Professional Audio Products Technical Bulletin 89–039

Model: APR-5002/5003

Subject: REDUCTION OF MASTER ERASE SIGNAL DISTORTION

Figure 1

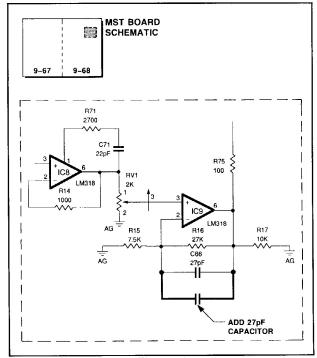
The erase transient at the end of a recorded segment may be too large in APR-5002/5003 units that contain an MST Assembly with part number A-7850-376-B or A-7850-377-B. To correct this problem, perform the modifications described in the following procedure.

MODIFICATION AND ALIGNMENT PROCEDURE MST BOARD (PN A-7850-376-B/377-B) Solder Side (See Figures 1 and 2.)

- 1. Verify that master bias level is 15Vpp.
- 2. Perform record alignments for both channels.
- 3. Load a bulk erased tape into recorder.
- 4. Remove MST Board from unit.
- 5. Solder a 27pF capacitor in parallel with C66.
- 6. Replace MST Board into unit.
- 7. Remove CH1 CNL Board from unit.
- 8. Remove heat sink plate from board.
- 9. Replace CNL Board on card extender.
